UNITED STATES PATENT AND TRADEMARK OFFICE

10/816,585

Office Action Summary

DETAILED ACTION

Fig 1

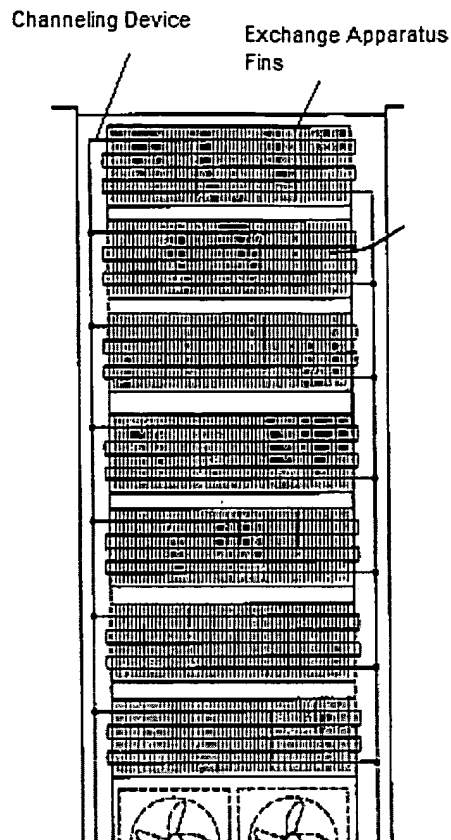
With respect to claim 8, Chu et al. further teaches that each heat exchanger includes a heat exchange fluid channeling device and a heat exchange apparatus in thermal communication with the heat exchange fluid channeling device (See present office action Fig 1 below).

With respect to claim 19, Chu 770 further teaches that the means for cooling air (21) includes a means (As illustrated in the present office action Fig 1 above) for channeling a heat exchange fluid and means (Fins as illustrated in POA Fig 1 above) for channeling the heat exchange fluid extends.

With respect to claim 20, Chu 770 further teaches that the means for heat exchange includes a plurality of heat exchange fins through which the means for channeling the heat exchange fluid extends (As illustrated in POA Fig 1 above).
